RESPONSES TO COMMENTS
RECEIVED ON THE
PRESIDIO TUNNEL TOPS EA

The Trust made the EA available for public review on October 28, 2015 (Trust 2015e). The Trust's announcements invited public comment for a 45-day period, which was extended by 36 days (concluding January 19, 2016) in response to public comment (Trust 2015f). During the public comment period, the Trust held two informational workshops on November 4 and December 3, 2015 to provide participants the opportunity to learn more about the project and issues covered in the EA, and to provide comments. Additionally, the Trust offered eight site tours between October 30, 2015 and January 15, 2016.

By the close or shortly after the public comment period for the project that ended January 19, 2016, the Trust received three letters, five emails and four comment cards from 10 interested individuals, two organizations and one public agency (see table below).¹ Several of the comments were nonsubstantive, generally expressing support for the project, and therefore required no response.

FIGURE 6-1 HYDROZONE PLAN

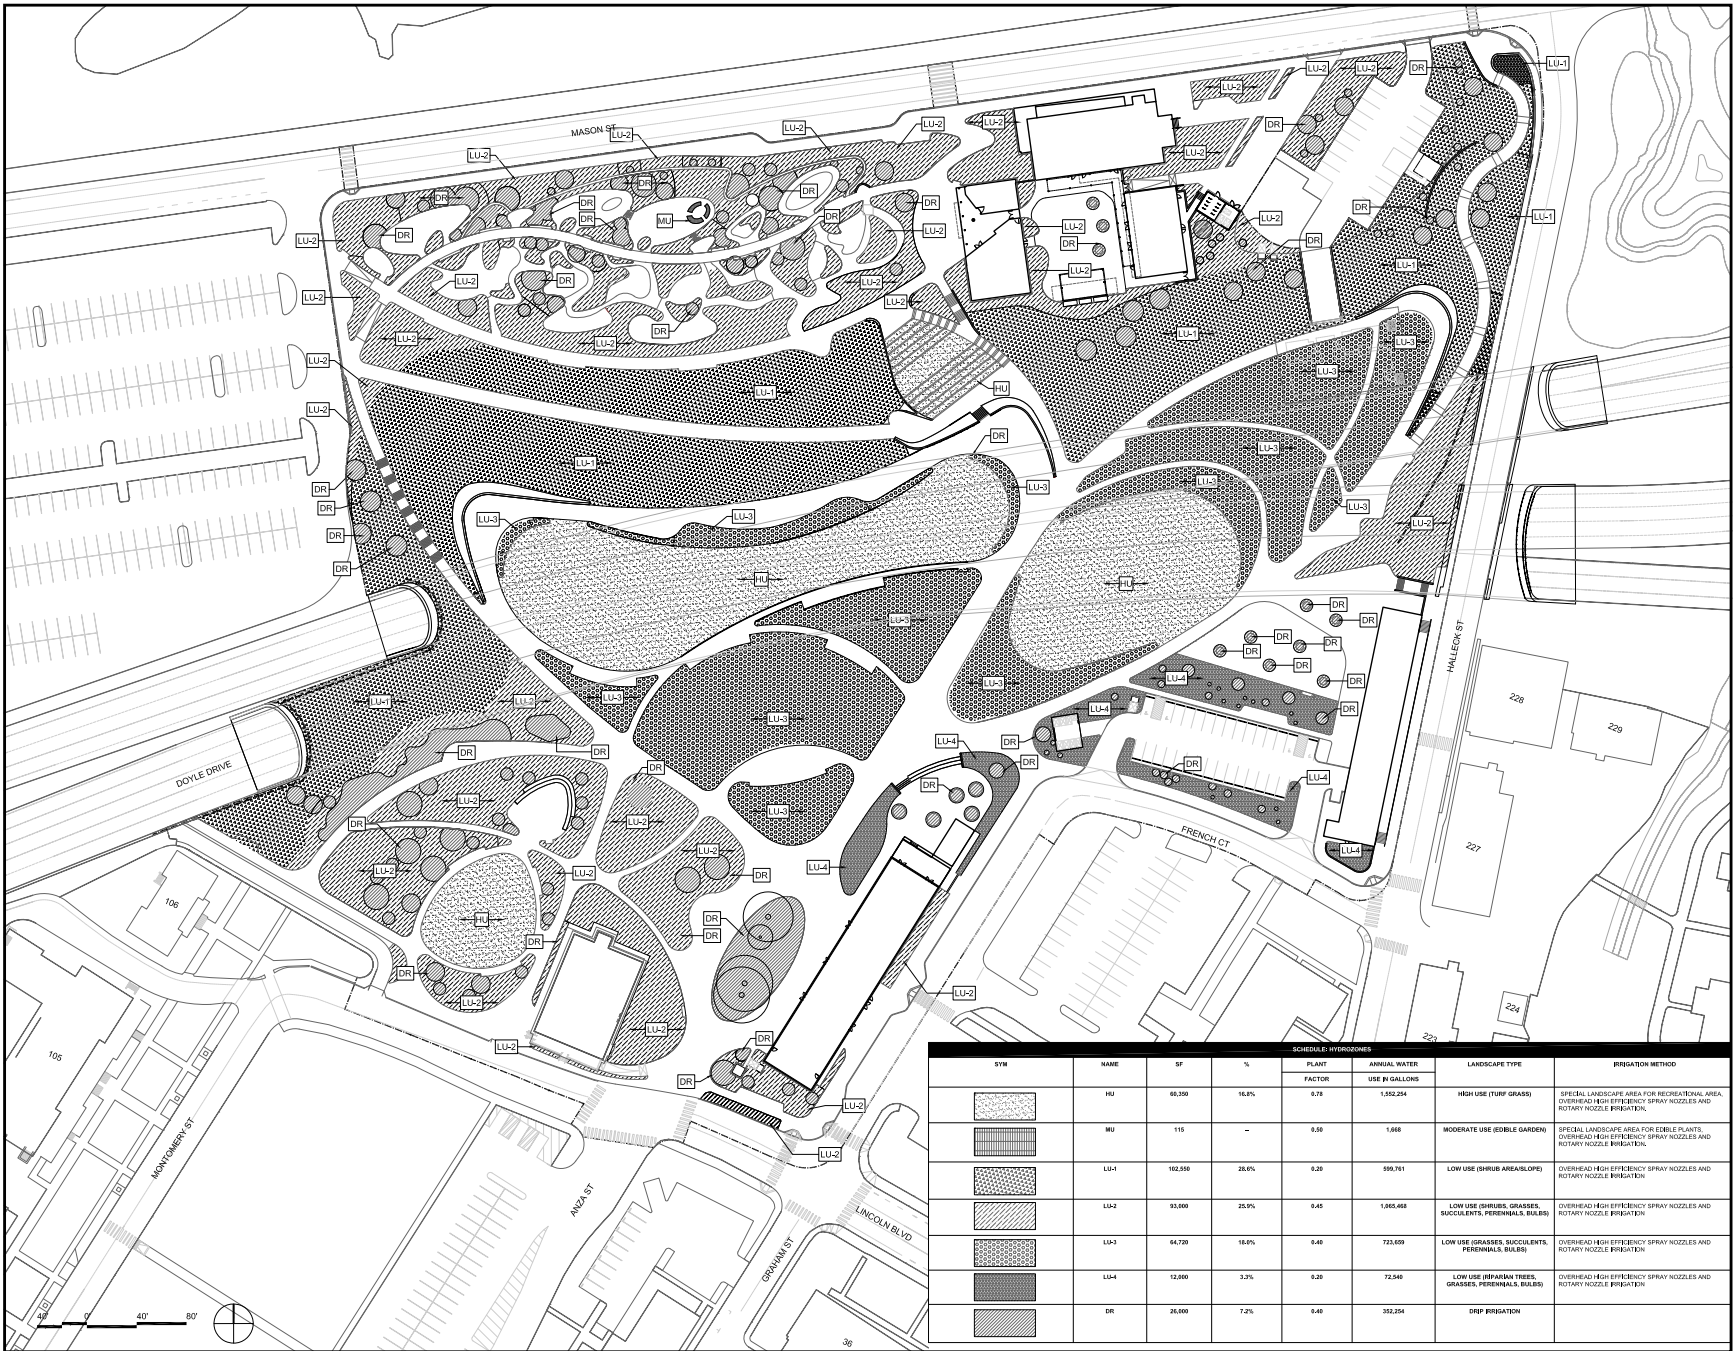
Comment: The Trust should reduce the lawn area further and select native meadow wildflowers and bunch grasses to echo the bluff plantings instead of the Main Parade to bring Alternative 3 much closer to the water demand of Alternative 1 (Amy Meyer, Golden Gate Audubon Society).

Comment: The Trust should further reduce impervious surfaces during schematic design and implement irrigation practices that minimize water use (Amy Meyer, Sharon Tsiu, NPS).

The latest schedule showing annual water use and irrigation methods for the various landscape types in the proposed project is provided in the Hydrozone Plan (see Figure 6-1). While there will be a nominal increase over current water demands, this increase is not expected to substantially change projected water usage for the Presidio. The Trust may elect to offset the increase in water usage by not irrigating other areas within the park.
